# Access Compliance Report

## Public Rights-of-Way

### (Curb Ramps)

Intersection ID: 8204	Main Street: BEATTIES_FORD_RD	Cross Street: CATHERINE_SIMMONS_AV	Location: NW
ADA ID: ECB25AAACE863	Ramp Type: Perp	Initial Pass/Fail: Pass	Overall Compliance: No
Severity Score: 0			
Codes/Mitigation Info/Possible Solution		Field Measurements/Component Compliance

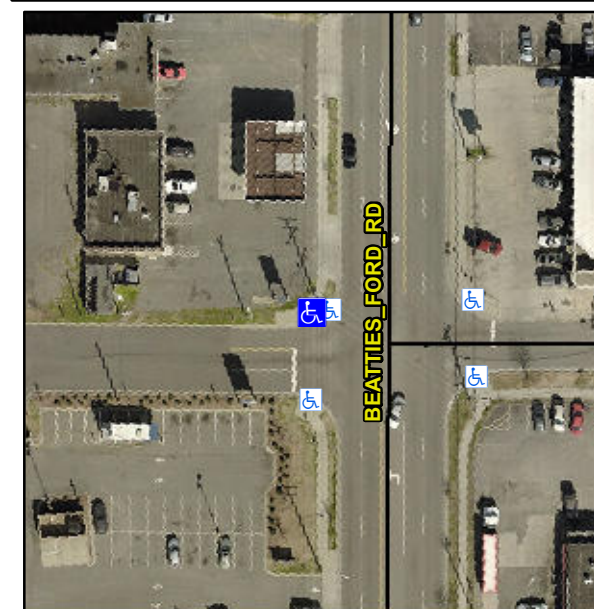
**Not Found, R304.2.1**

**Remove & Replace Entire Ramp.**
